# Groundwater Transfer Review Summary Form

Transfer/PA # T- 13528

Application: T-13528

Applicant Name: City of Redmond

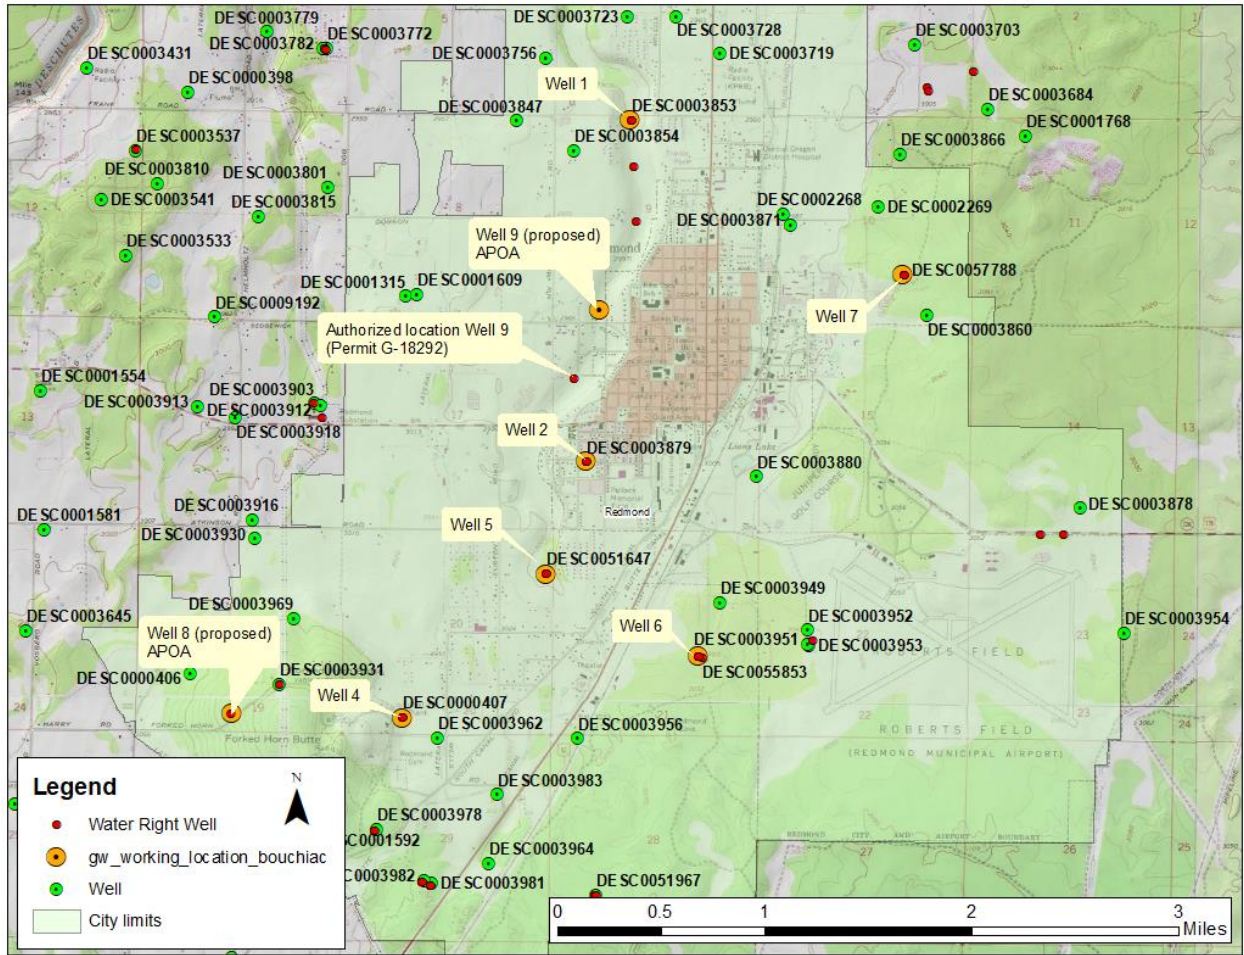
1. Basic description of the changes proposed in this transfer: This transfer proposes changing the location of proposed Well 9 on permit G-18292. The proposed change will bring the location of proposed Well 9 under this permit in line with the location of proposed Well 9 under Certificates 87796, 89448, 89447 and 89415 (as amended by recent transfer T-13391).

4. a) Will this proposed change, at its maximum allowed rate of use, likely result in an increase in interference with **another ground water right**?  
 Yes     No    Comments: The proposed location change brings Well 9 approximately 1800–feet nearer to proposed Well 11. Proposed Well 11 is included on the same water rights as proposed Well 9.
